# 802.3da TCI Clause 188 and Clause 189

Stephan Schreiner  
Rosenberger Hochfrequenztechnik GmbH & Co. KG  
September 2025

## TCI Return Loss

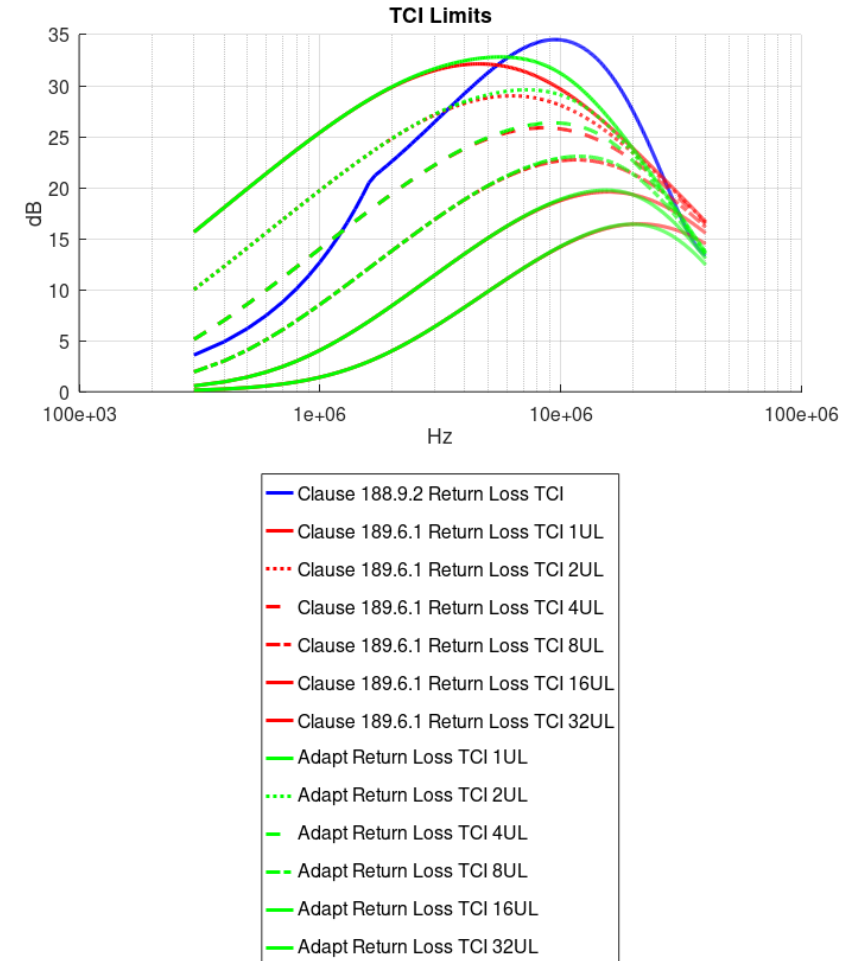
- Measurement of T-Adapters indicates a lower return loss than clause 189 TCI return loss above 25 MHz (ramp has more dB/Dec)
- The main signal content of the DME is in the frequency range between 5 MHz and 17 MHz
- Adapt equation from clause 189 TCI

- Difference in the main region is minor (even a little bit more stringent)

$$RL(f) = -10 * \log_{10} \left( \frac{10e3 + \frac{(40.192f)^2}{N_{UNIT}}}{10e3 + \left(\frac{2010f}{N_{UNIT}}\right)^2} + \frac{f^{3.5}}{9500e3} \right) \text{ dB}$$

## TCI Insertion Loss

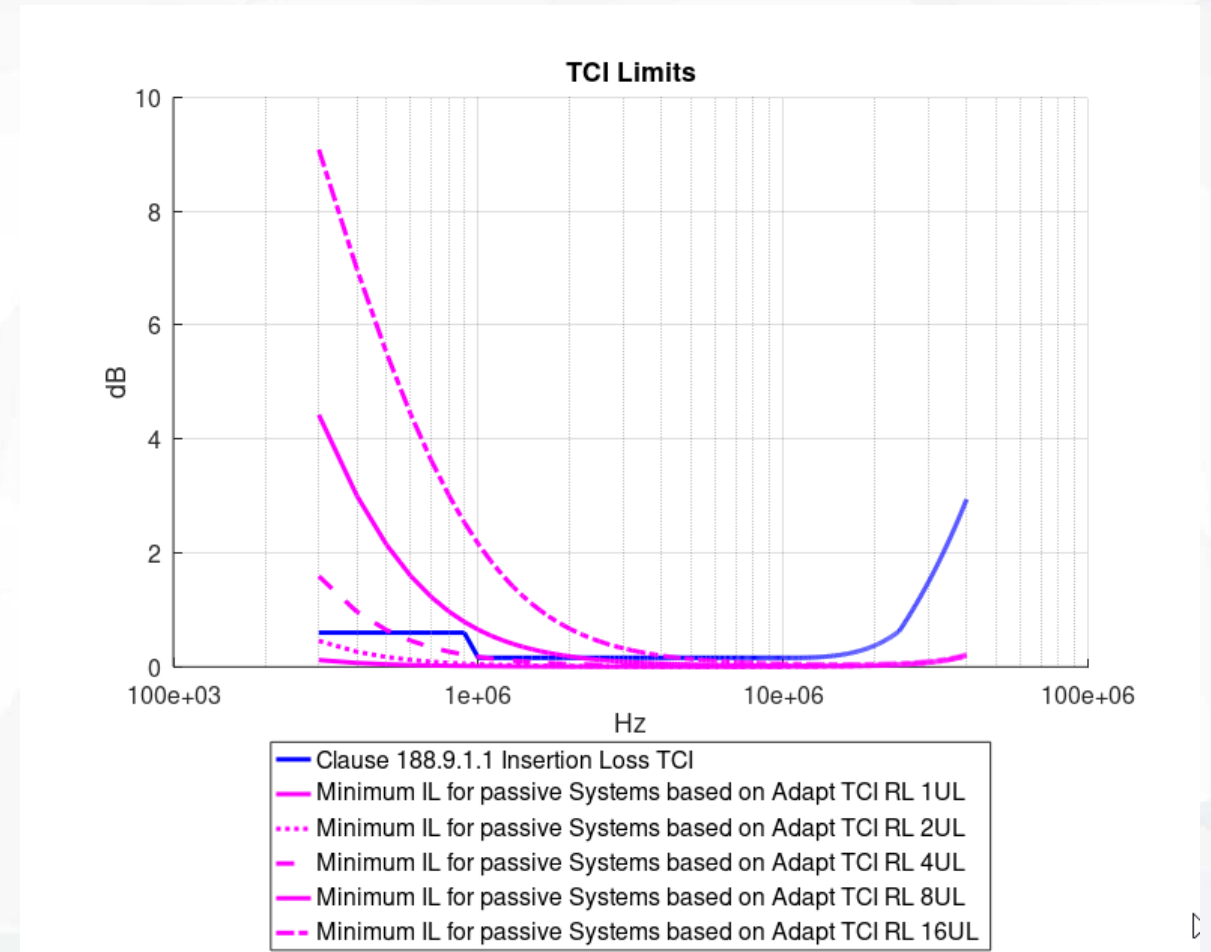
- The intention of the clause 189 TCI return loss is to allow smaller power inductors in case of higher unit loads
- Therefore the new return loss equation was generated
- However, at this position, the required network has to be passive – thus the S-Parameters needs to be passive
  - More simple – reflected energy can't be transmitted anymore
  - In numbers: If we have a RL=3dB, the IL must be greater or equal 3dB
- $S_{dd21} \leq 10 \cdot \log_{10}(1 - 10^{-(S_{dd11}/10)})$
- With the clause 189 TCI return loss and the TCI insertion loss of clause 188, passivity is only given up to 2UL.
- Thus, inserting clause 189 TCI return loss for higher unit loads is only useful if TCI insertion loss is also changed
- Possible solutions:
  - Insert an IL curve which is dependent on ULs
  - Remove TCI IL in general
  - Do nothing and make no use of the UL RL benefit
- Don't know what is better

## UL16 Case, Lossless ideal transmission lines – channel Simulation

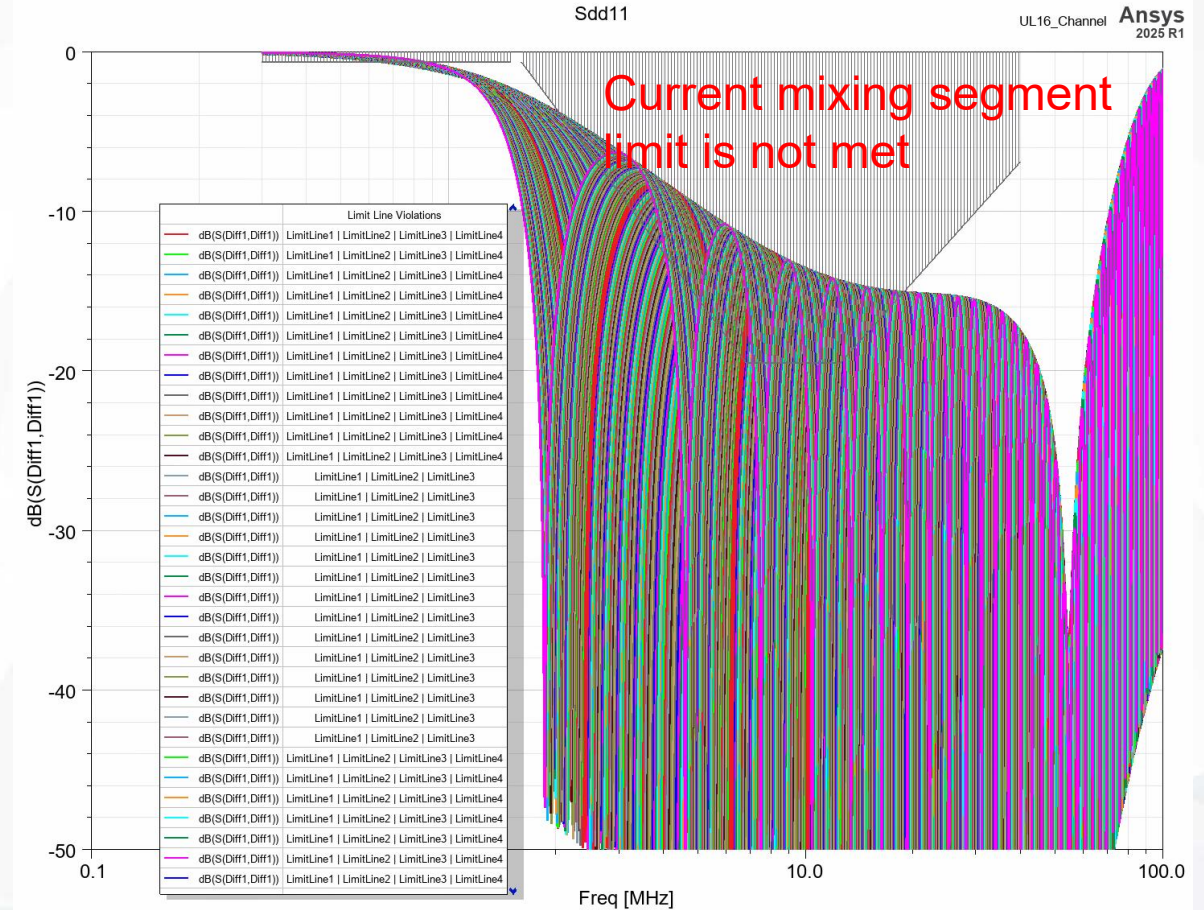
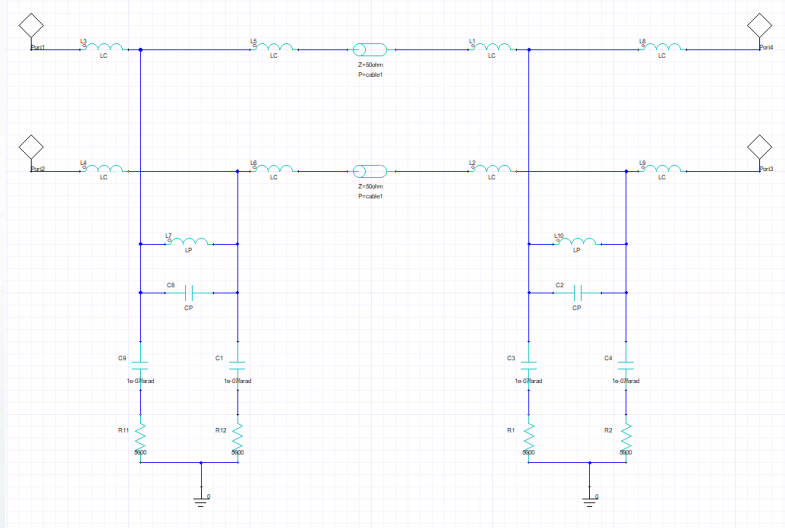
- Setup:
  - 2 Nodes
    - According to UL16 Limit
    - Ideal loss less transmission lines, distance variations in 0.25m steps from 0.25m to 50m
  - Current Mixing Segment Limit is harmed in multiple cases

## UL4 Case, Lossless ideal transmission lines – channel Simulation

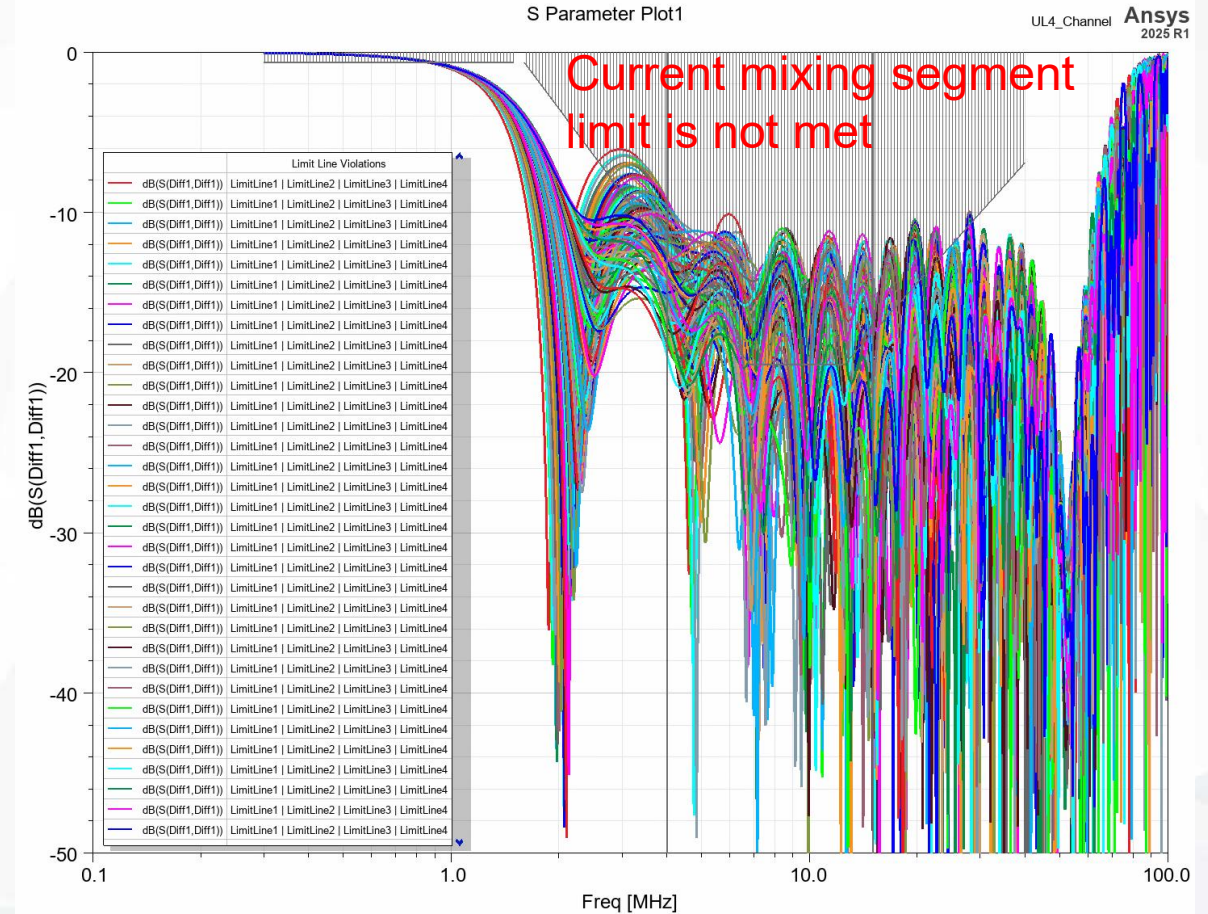
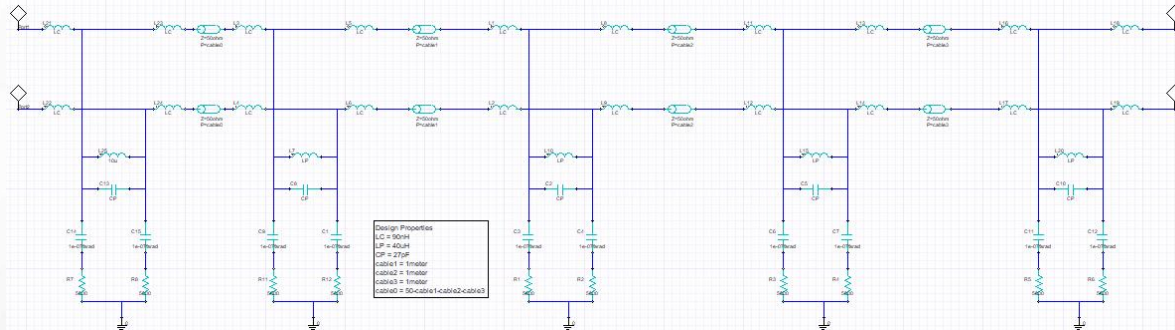
- Setup:
  - 4 Nodes according to UL4 Limit, first Node according to UL16
  - Transmission Lines 2,3,4 varied between 1m and 15m in 3m Steps, all combinations. Transmission Line 1 tuned to result in a 50m channel
- Current Mixing Segment Limit is harmed in multiple cases

## UL2 Case, Lossless ideal transmission lines – channel Simulation

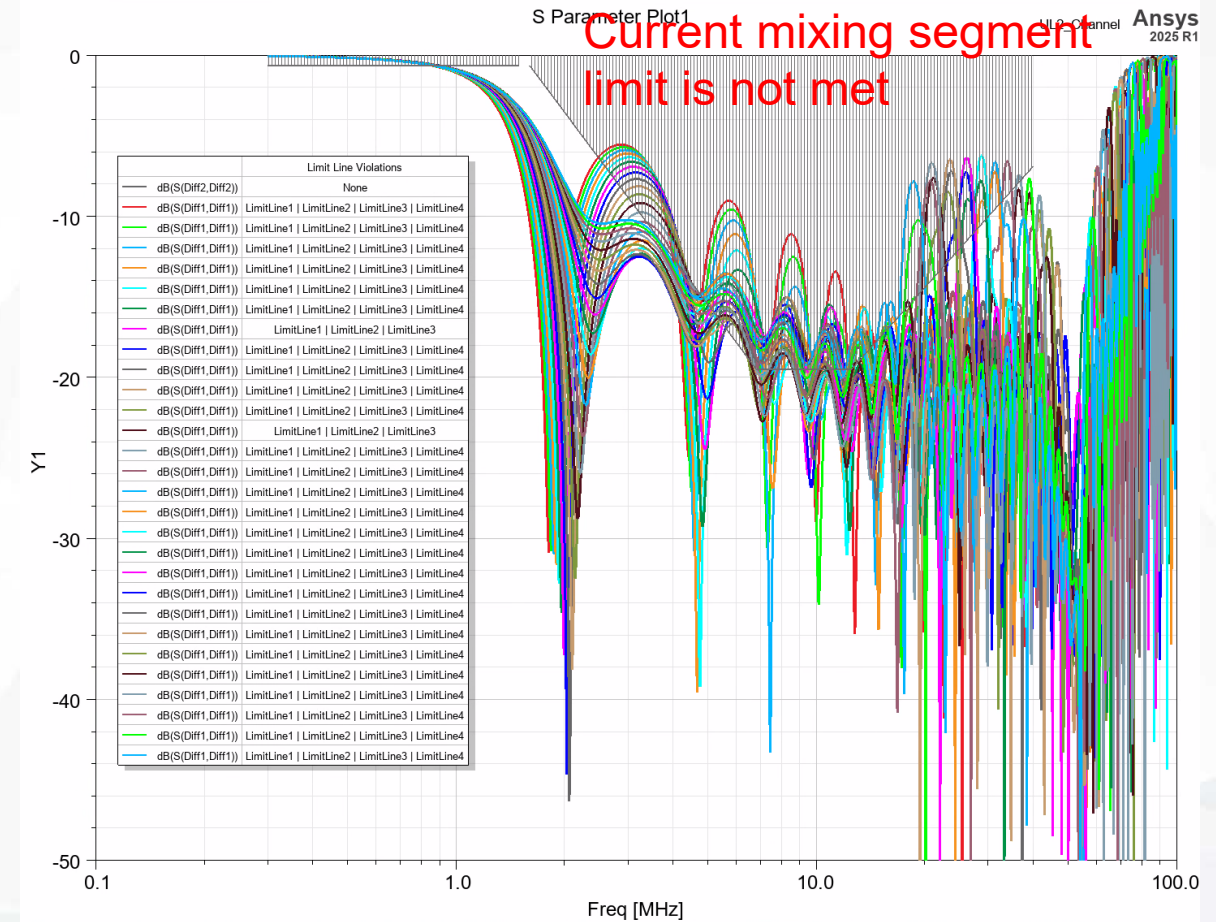
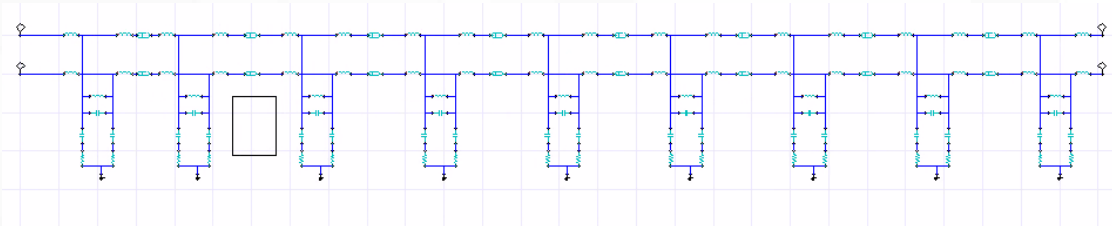
- Setup:
  - Nodes: 1 x UL16, 8 x UL2,
  - Transmission Lines 1 to 7 same length varied between 1m and 7m in 0.25m Steps, Transmission Line 0 calculated to get a 50m over all
- Current Mixing Segment Limit is harmed in multiple cases

## UL1 Case, Lossless ideal transmission lines – channel Simulation

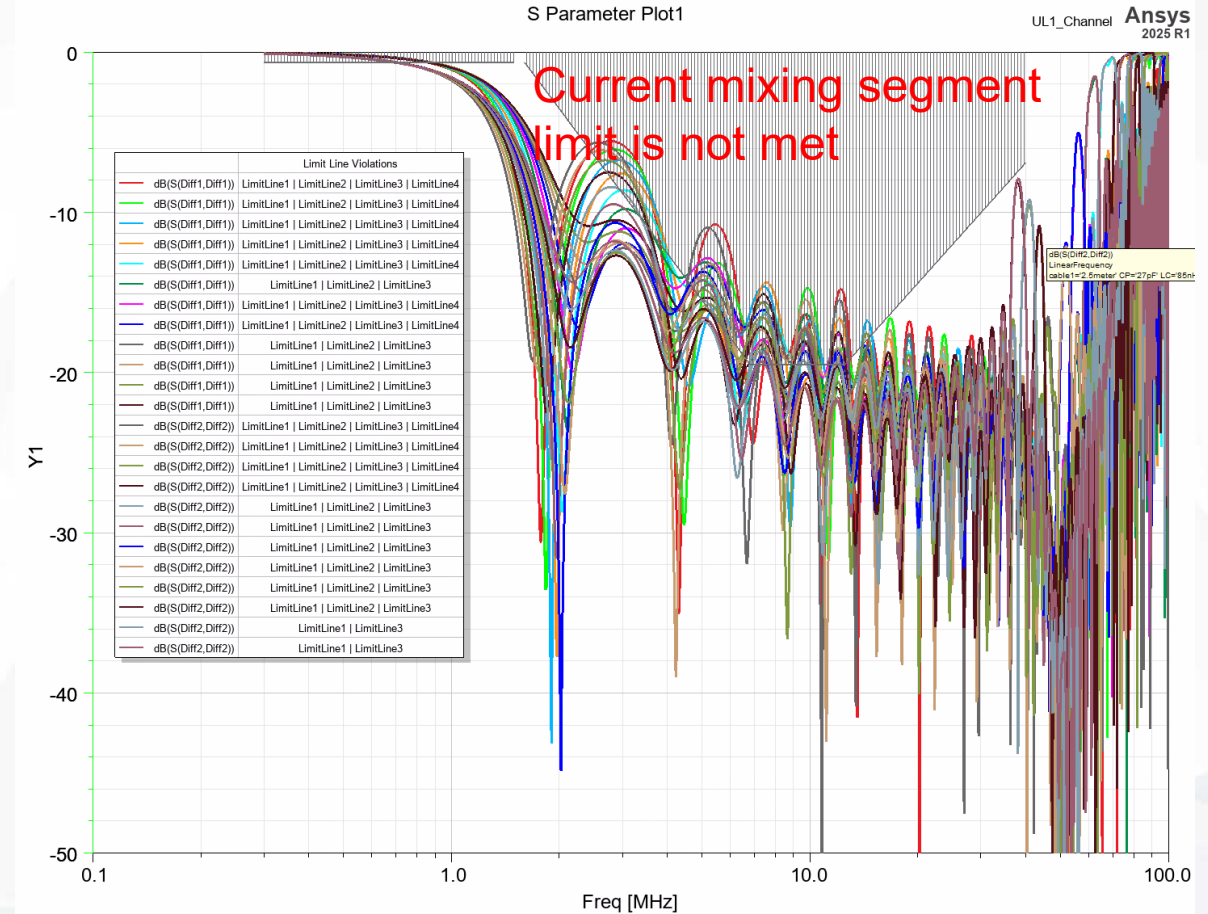
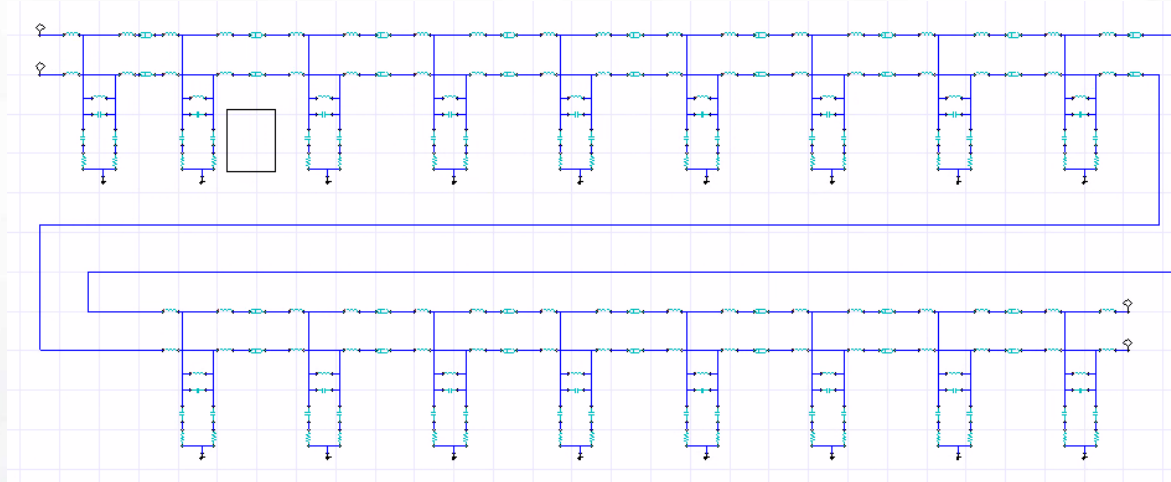
- Setup:
  - Nodes: 1 x UL16, 16xUL1
  - Transmission Lines 1 to 15 same length varied between 0.25m and 3m in 0.25m Steps, Transmission Line 0 calculated to get a 50m over all
- Current Mixing Segment Limit is harmed for short distances of 0.25m between nodes 1 to 15.

## Version – Prototype 2 Material B, 27pF

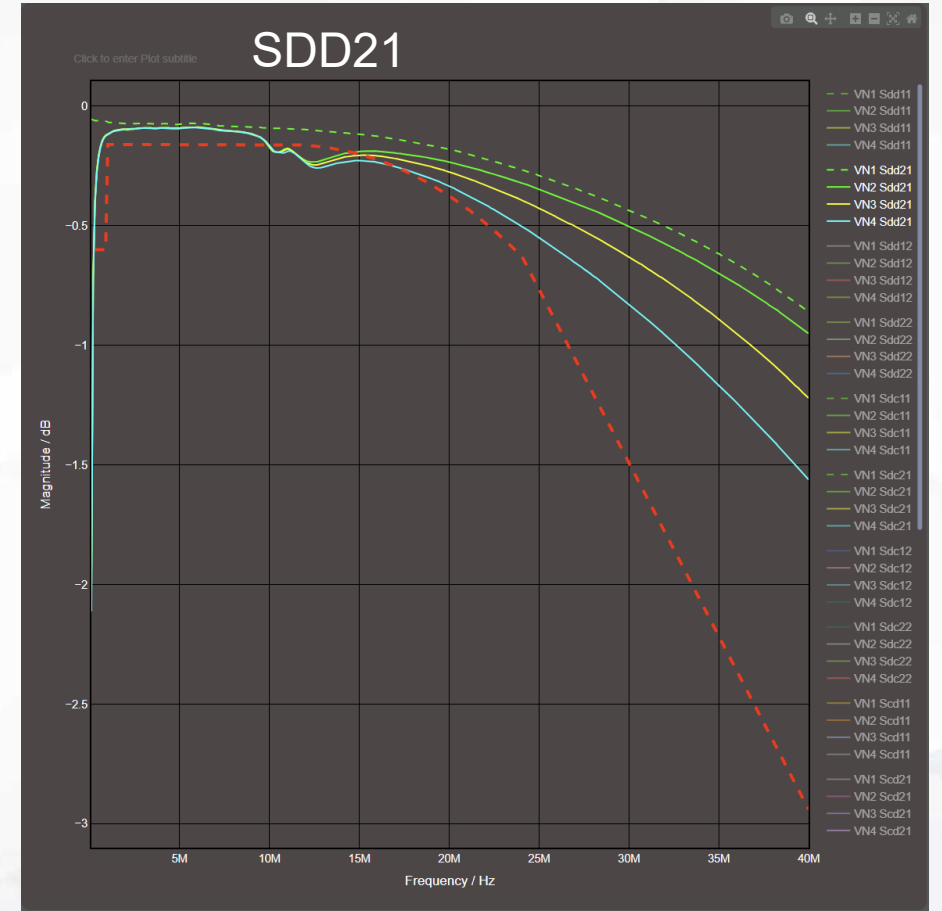
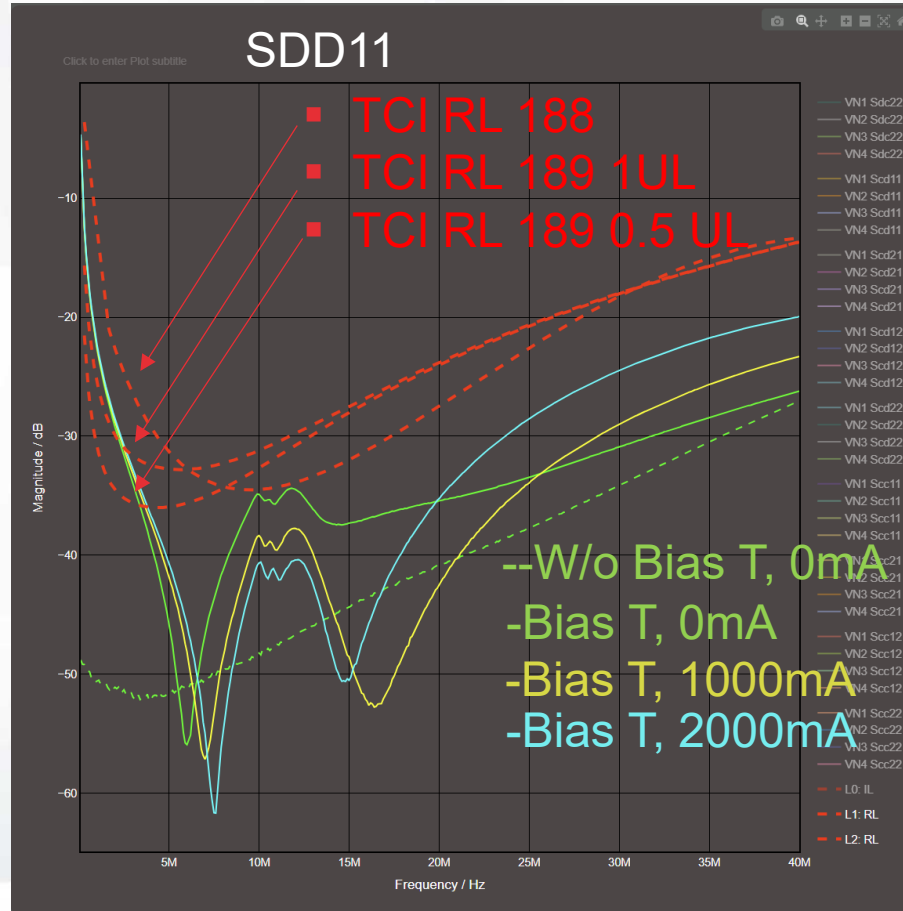
- Bias Tee shows significant influence to RL and IL
- Compensated T fullfills spec, however size of compensation ferrit is relatively long
- May be not economically feasible
